Date:	2020-03-06
No.:	INITIAL SUBMITTAL
Description:

FILED: LOT 1, BLOCK 1, CHASE LUMBER SUBDIVISION FILING NO. 1 SITUATED IN THE SE 1/4 OF SECTION 33, T14N, R16W OF THE 6TH P.M. CITY OF AURORA, COUNTY OF ADAMS, STATE OF COLORADO

DRAINAGE PLAN

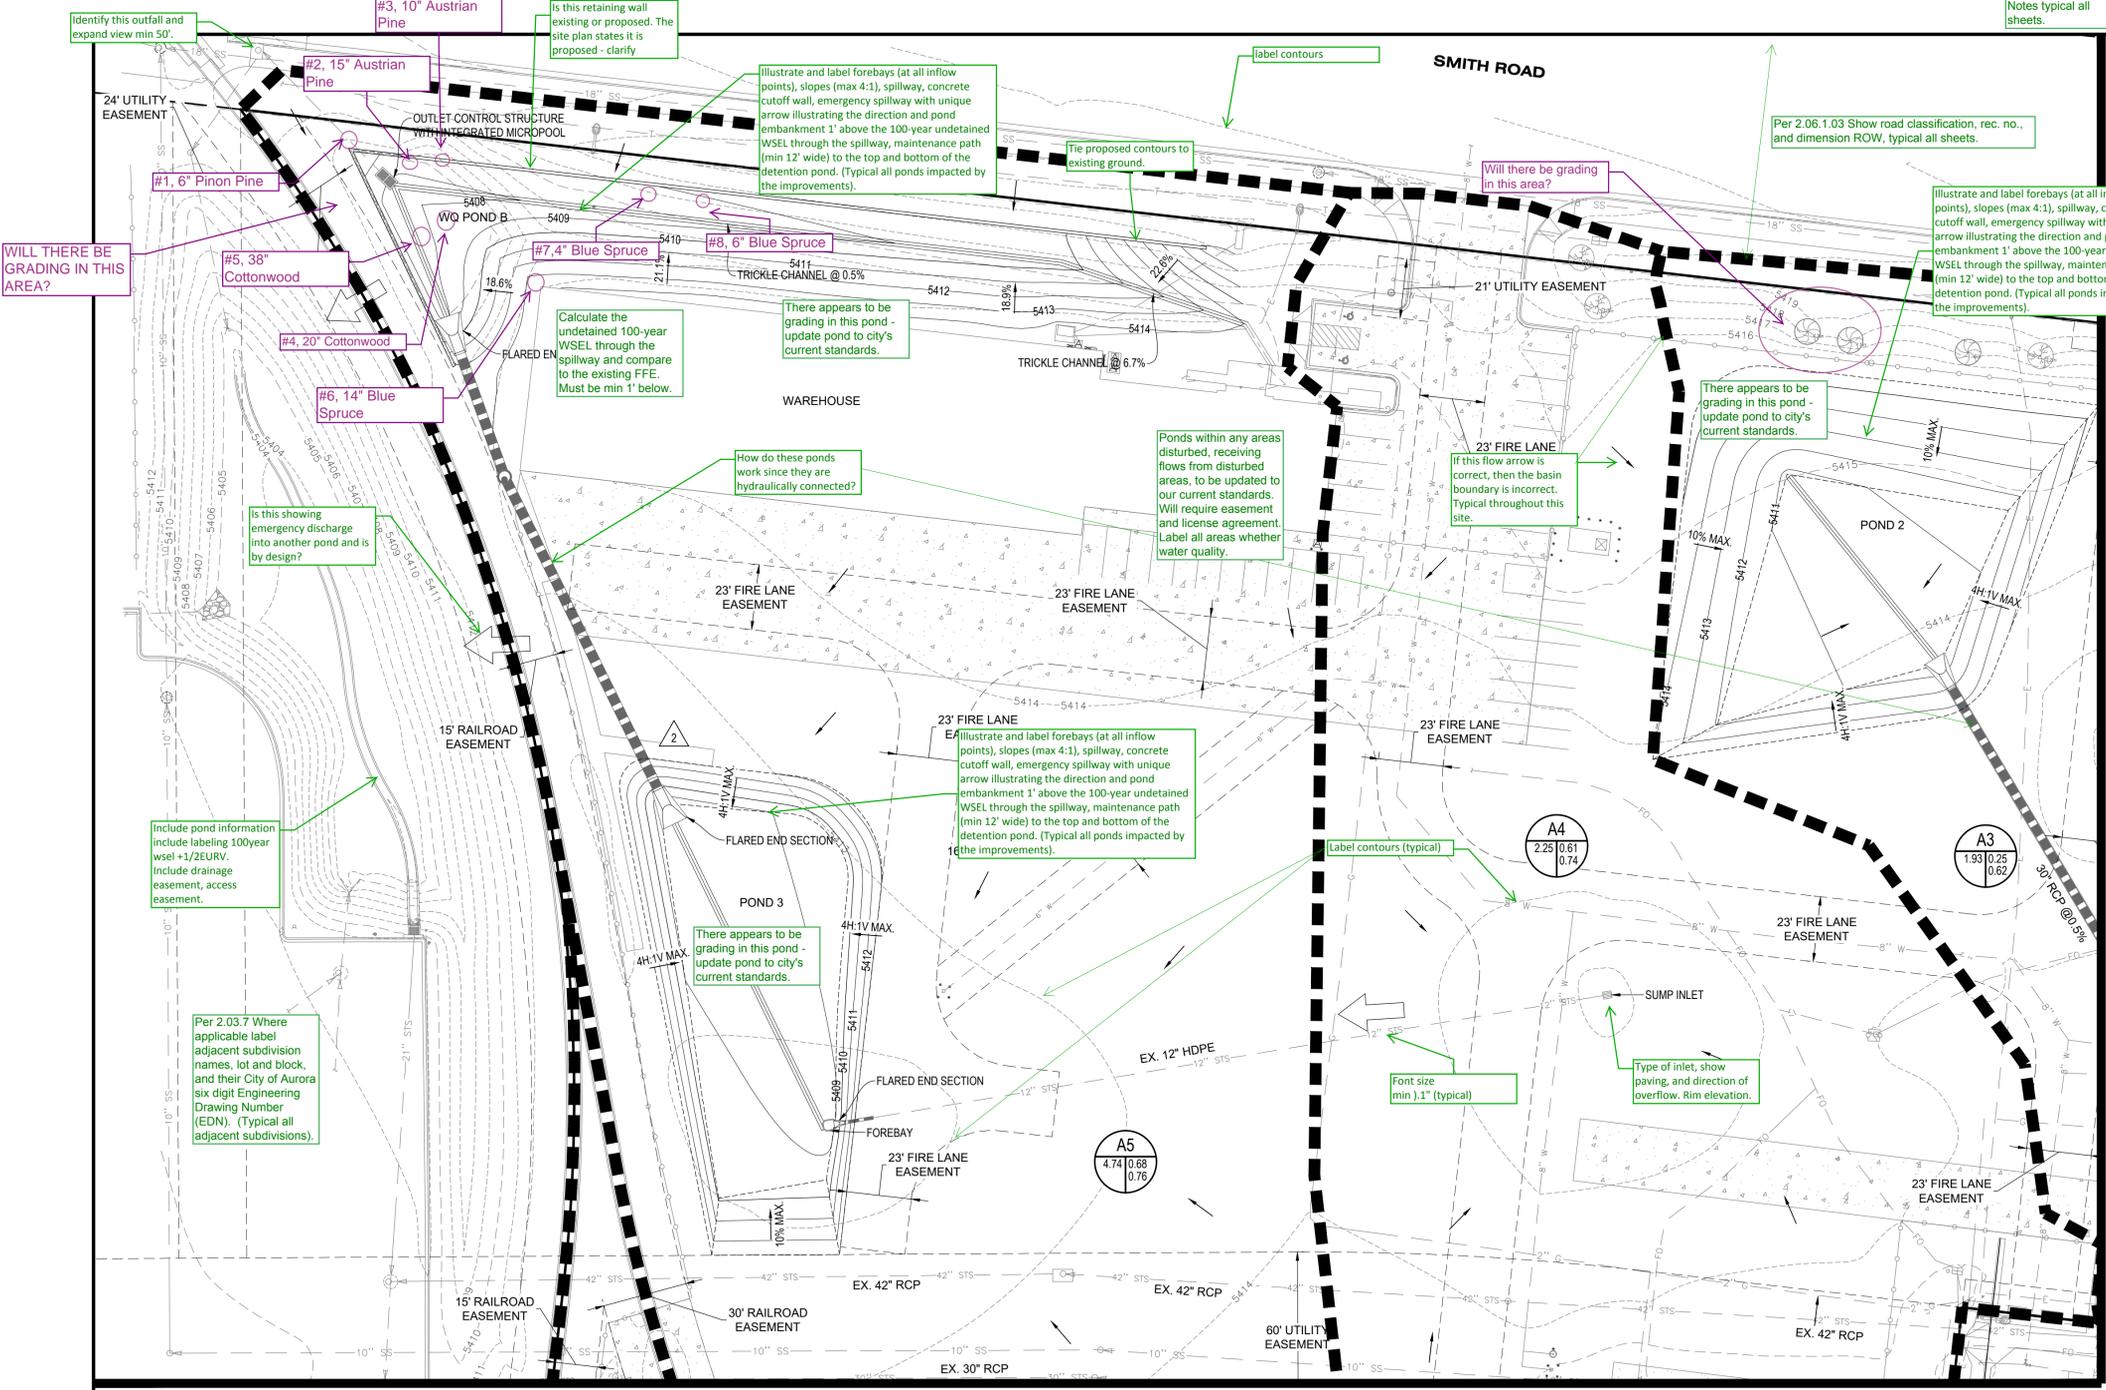
Per 2.06.1.07 add flow direction arrows, particularly at intersections. (Include these arrows within your site (slopes labeled) and minimum 50' outside of the site).

Add flow arrows to illustrate runoff direction to existing facilities.

Include flow arrows around the buildings and within the site in enough detail to show conformance with the criteria outlined below.

Per 2.08.1.06 Minimum 0.50% slope on all concrete surfaces, minimum 1% slope on all asphalt surfaces, minimum 2% slope on all grass-lined swales and landscape areas.

Per 2.08.1.06.2 The slope away from the building shall have a minimum grade of five (5) percent for the first ten feet or to the property line. Impervious surfaces within ten feet of the building foundation shall be sloped a minimum of two (2) percent away from the building.

Per Section 2.34 H add: "All storm sewer is Public/Private (choose one) and sized for the ___ year event"

Drainage - Add "All storm sewer is (choose: private/public) and is sized for the ___ yr event, unless otherwise noted.

WILL THERE BE GRADING IN THIS AREA?

Is this showing emergency discharge into another pond and is by design?

Include pond information include labeling 100-year wsel +1/2EURV. Include drainage easement, access easement.

Per 2.03.7 Where applicable label adjacent subdivision names, lot and block, and their City of Aurora six digit Engineering Drawing Number (EDN). (Typical all adjacent subdivisions).

Calculate the undetained 100-year WSEL through the spillway and compare to the existing FFE. Must be min 1' below.

There appears to be grading in this pond - update pond to city's current standards.

How do these ponds work since they are hydraulically connected?

Ponds within any areas disturbed, receiving flows from disturbed areas, to be updated to our current standards. Will require easement and license agreement. Label all areas whether water quality.

Illustrate and label forebays (at all inflow points), slopes (max 4:1), spillway, concrete cutoff wall, emergency spillway with unique arrow illustrating the direction and pond embankment 1' above the 100-year undetained WSEL through the spillway, maintenance path (min 12' wide) to the top and bottom of the detention pond. (Typical all ponds impacted by the improvements).

There appears to be grading in this pond - update pond to city's current standards.

Label contours (typical)

Font size min 1/16" (typical)

Type of inlet, show paving, and direction of overflow. Rim elevation.

Clearly define the limits of proposed grading and improvements to determine detention and water quality improvements/requirements. Clearly define the limits paving and curb and gutter.

Per 2.03.5.07.1 The benchmark number, description and elevation... Desc: CHISELED SQ CENTER W EDGE CO INLET @ S PCR SE COR RIFLE ST & E 25TH AVE. Verify this work is on the 88 datum - it appears to be, however verify datum.

DETENTION POND TRIBUTARY AREA = 6.98 ACRES	Correct elevations and additional information requested.
MICROPPOOL WSEL = 7.65'	
WQCV = 0.115 ACRE-FEET; WQCV ELEVATION = 9.42; DEPTH = 1.77'	
EURV = 0.419 ACRE-FEET; EURV ELEVATION = 10.71; DEPTH = 3.06'	
100-YEAR+1/2 EURV = 0.861 ACRE-FEET; 100-YEAR+1/2EURV WSEL = 14.57; DEPTH = 6.92'

For Detention Ponds: Drainage easements are required for all ponds. Access easements from the drainage easement to public right of way are required for maintenance access. Show/label pond maintenance access to the pond bottom and top of the outlet structure. Indicate direction of emergency overflow. A license agreement is required for the entire detention pond.
